Kansas Department of Agriculture  
 Division of Water Resources  
**CHANGE: P/U WORKSHEET**

RE: Filed Office Application for Change  
Water Right, File Nos. 12,315; 12,456; 13,865; 16,803; 21,819; 21,820 & 23,295

# CHANGE IN PLACE OF USE WATER RIGHT

RE: Applications for Change in Place of Use  
Water Right, File Nos. 12315, 12456, 13865, 16803, 21819, 21820 & 23295

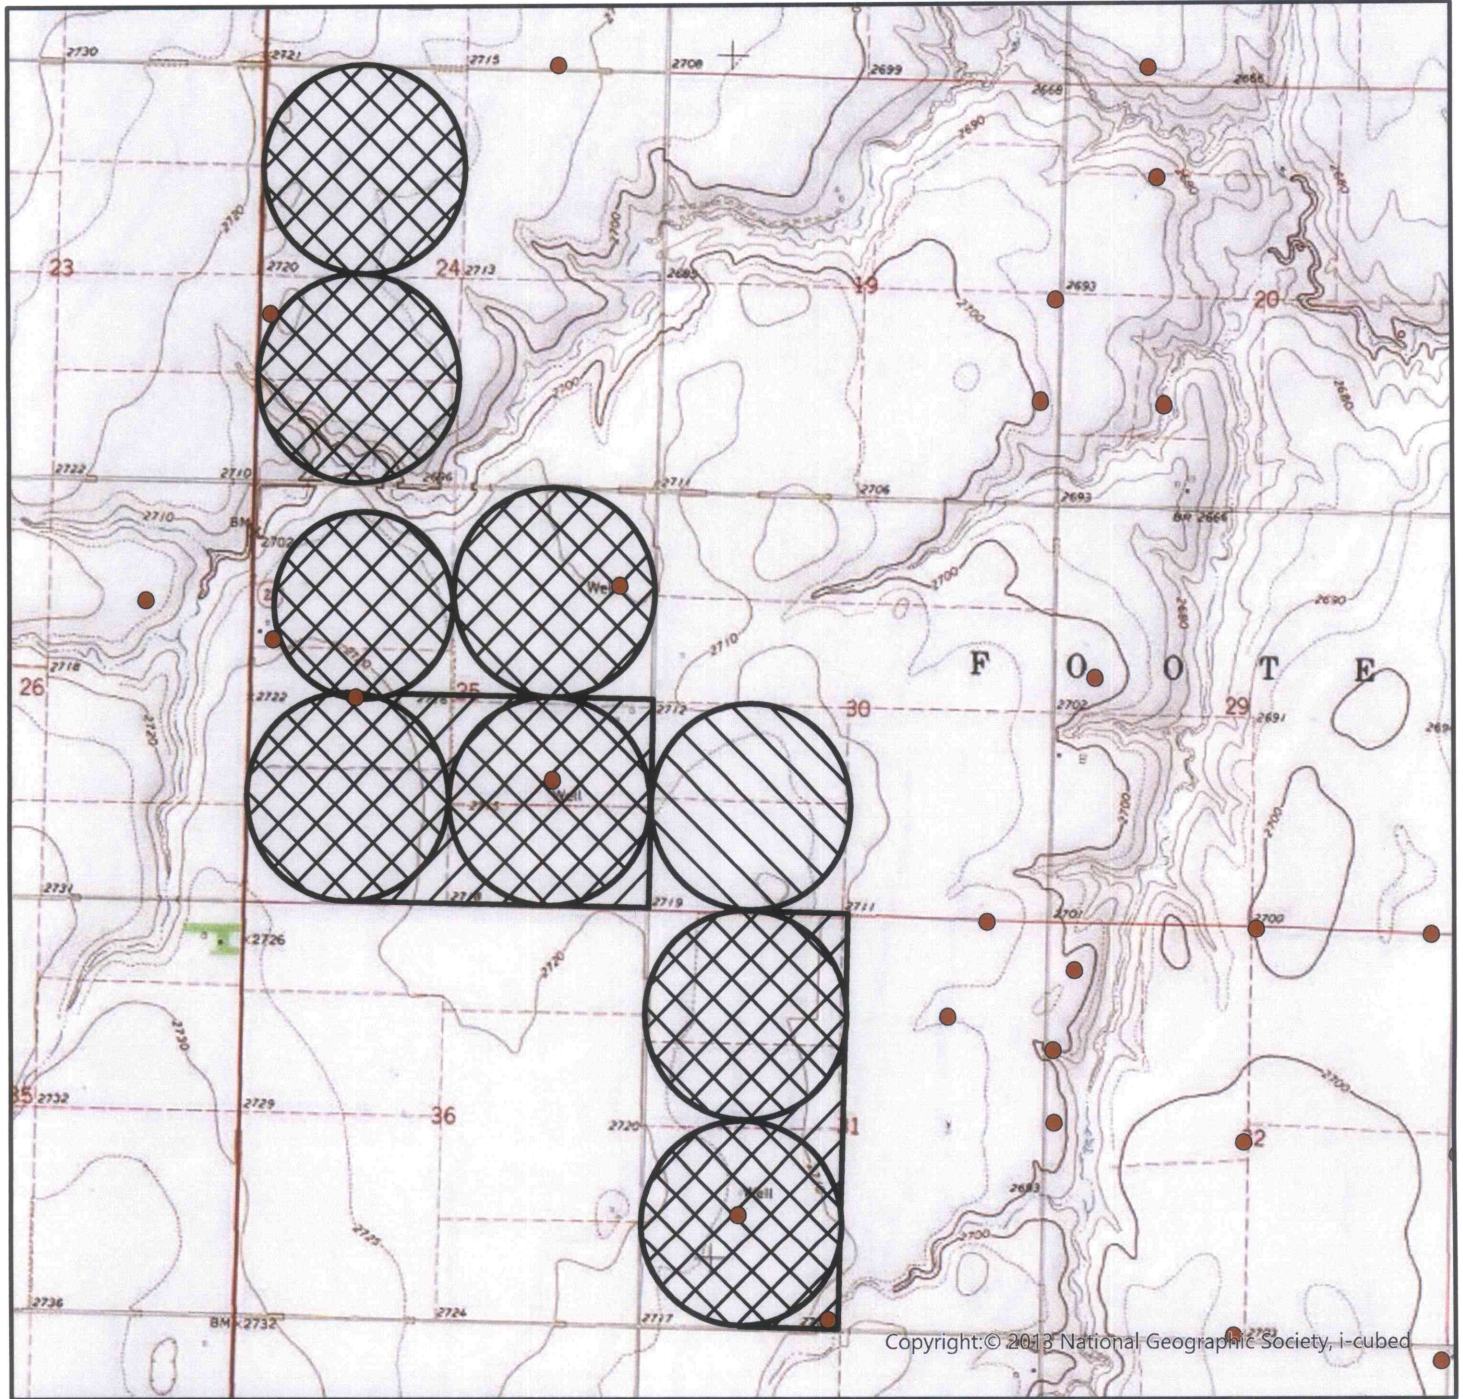
We have reviewed the applications for the above referenced water rights. The proposals are not in conflict with the Management Program of the Southwest Kansas Groundwater Management District No. 3 (GMD3). The proposed change in place of use will make a complete overlap in authorized place of use while rearranging acres to better suit the operation. In accordance with K.A.R. 5-5-11(b), the proposed acres are within the allowance of the base acres for the water rights. It is therefore recommended that the applications be approved at this time.

Is Proposed PU overlapping existing WRs? Maintaining a complete overlap while bringing in new acres for the operation.

**Proposed acres:**

250 acres W2 24-24-28

475 acres 25-24-28

125 acres SW 30-24-27

250 acres W2 31-24-27

**Total = 1100 acres**

Is a waiver needed: No, staying within the base acres range as allowed by the rules.

Recommendation: after review of all information, current area rules appear met. Staff recommends approval of the applications.

2. On and after the effective date of this summary order, the authorized place(s) of use shall be located substantially as shown on the topographic map accompanying the application to change the place of use.  Applicable  Not Applicable
